Design Principles and Standards

Proposed replacement photos

SUGGESTIONS FOR PHOTOGRAPH DELETIONS AND PROPOSED REPLACEMENTS ARE INDICATED IN THE RED BOXES ON THE FOLLOWING PAGES.

Page 85

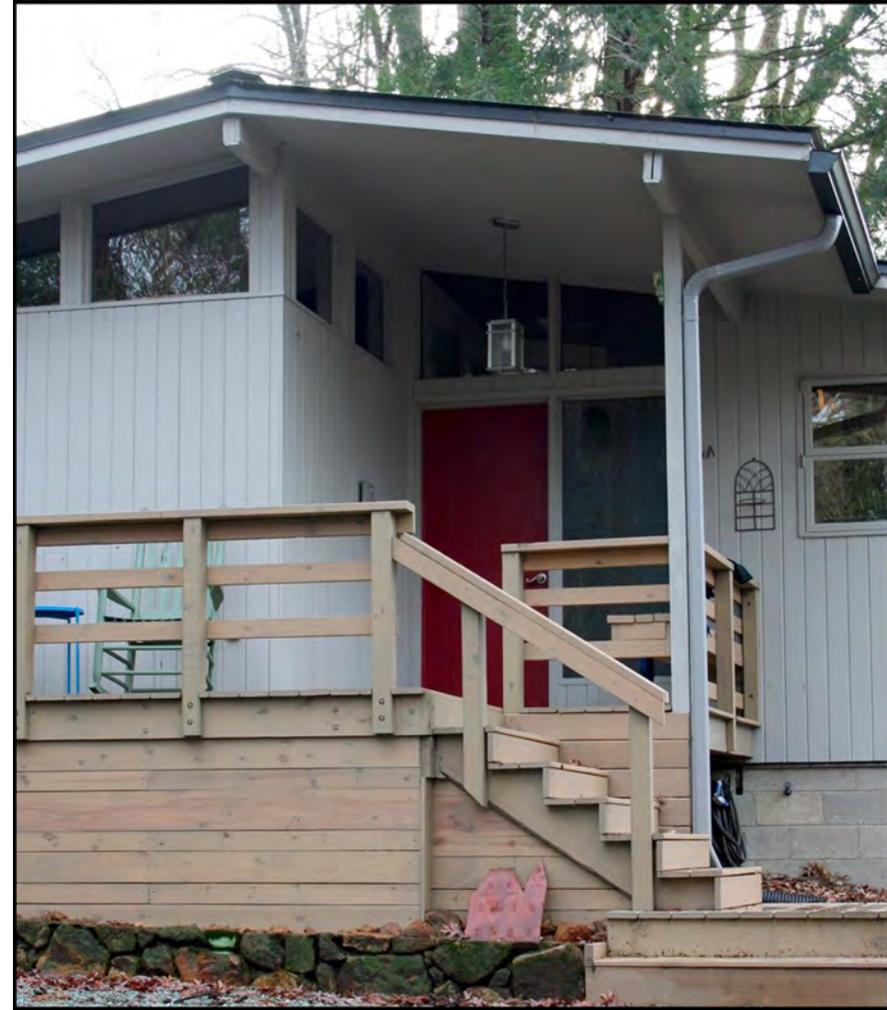
“Streamlined surfaces and finishes are typical on Modernist-style buildings”

There are better, more interesting examples of modern architecture in our districts. In this photo, the railing looks unfinished.

DELETE THIS PHOTO
REPLACE WITH PHOTO NEXT PAGE

119 Battle Lane

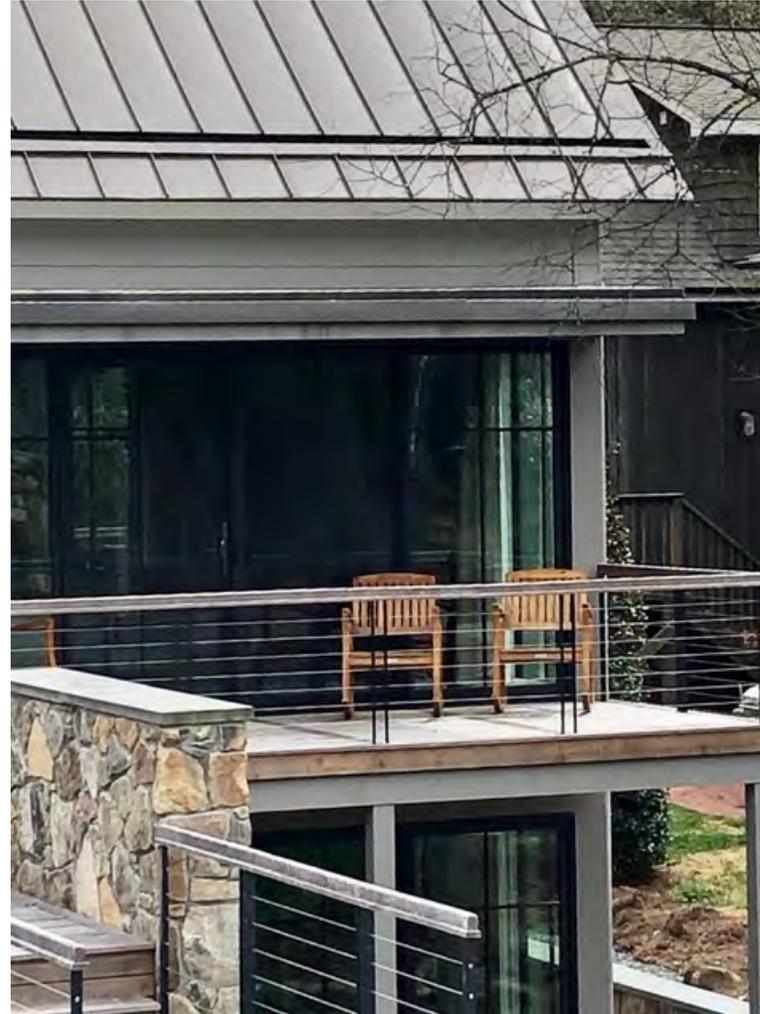
This photo depicts some of the more modern features, such as clear flat surfaces, simple lines, larger windows, minimal ornamentation, unlike those found in the districts' older home styles.

USE THIS PHOTO ON PAGE 85
